SUNSCAPE® ROOF COVERING SYSTEM INSTALLATION GUIDE - ADDENDUM

How to splice SUNSCAPE aluminum profiles for installation of a 16ft Sunscape polycarbonate panel.

Form 951 ADDENDUM 100225 RP

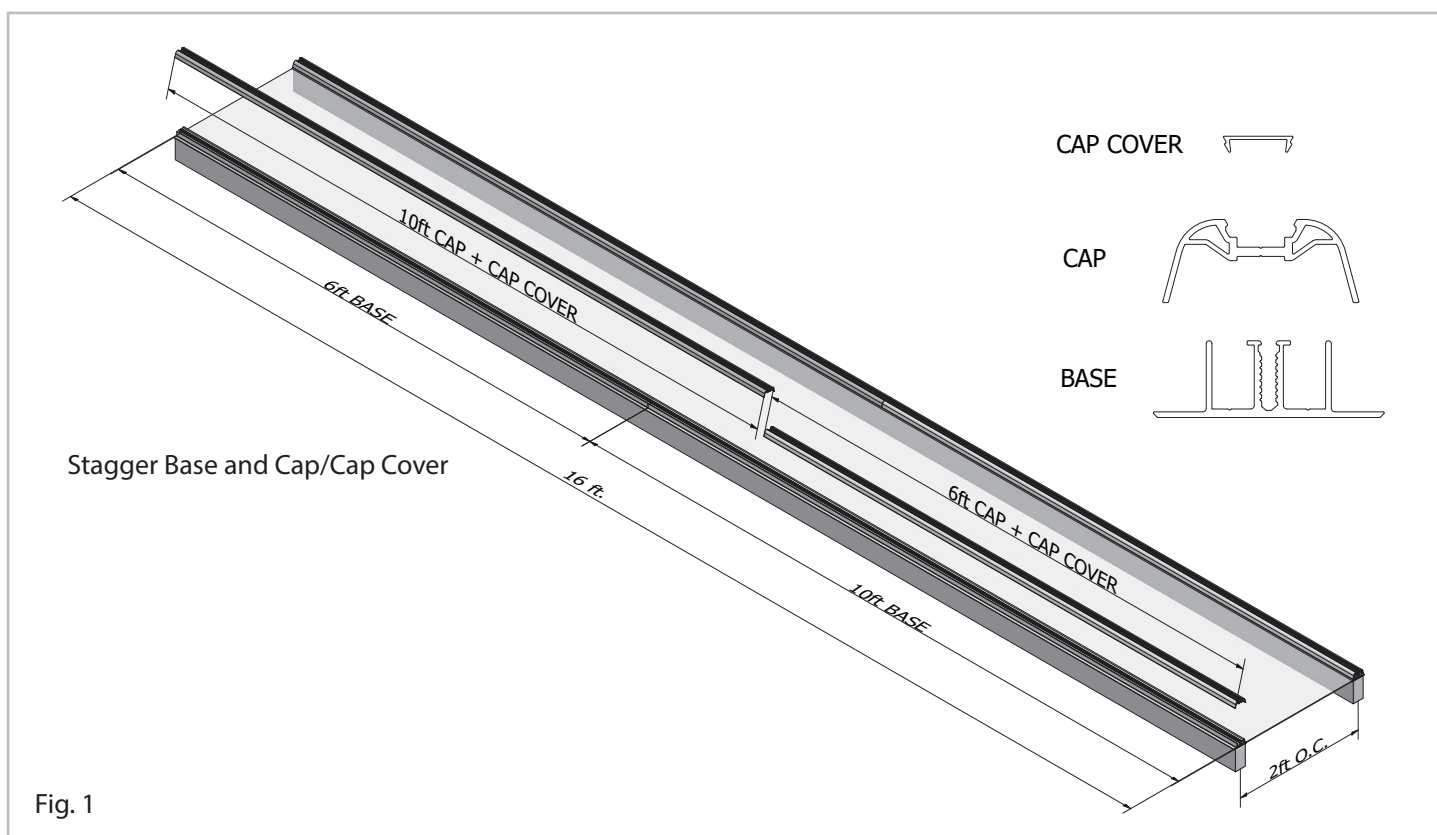
Each individual vertical support should be installed as shown in Fig. 1.

All seams must be staggered – the base and cap should always be staggered as depicted in Fig. 1.
